DEC COMMENT No. 1:

Evaluate the installation of an underflow baffle at Diversion Chamber 5 for floatables control.

DEC Comment No. 16 on the December 2014 Flushing Creek LTCP:

Figure 4: Section of TI-R51

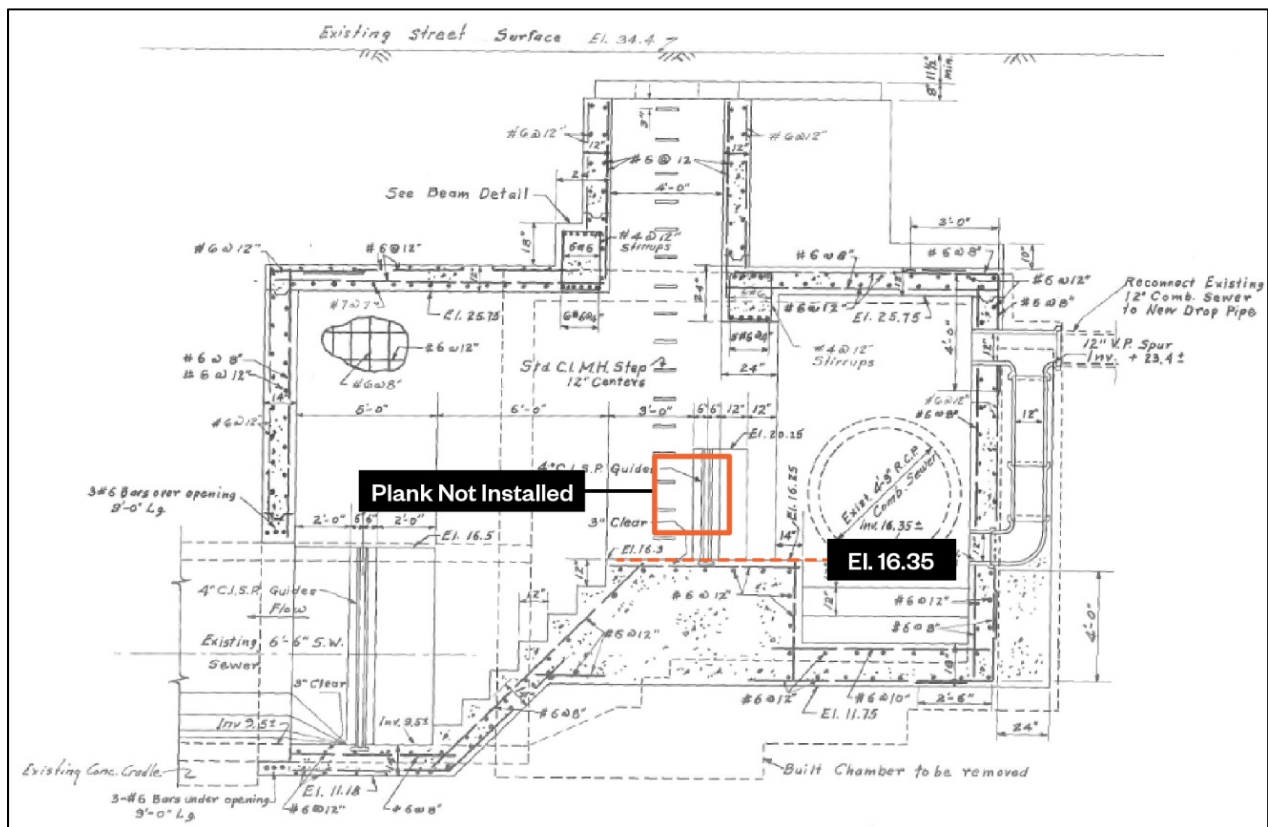
Evaluate floatables control at TI-011 and confirm that feasibility for including floatables control as part of the selected alternative.

The original construction drawings of TI-R51 show that the existing structure has a 78-inch overflow line, with a 7-footwide, cast-iron, stop-plank weir. However, a review of the model and the DEP's Regulator Database indicate that the stop plank is not installed (see Figure 4). As such, the control elevation is at the invert of the control structure and modeling indicates that a baffle would adversely impact the upstream HGL. Additionally, any baffle would need to be installed along the top of the dry weather flow channel and not perpendicular to the flow, which is required for floatables capture. Installing a baffle within TI-R051 is not feasible.
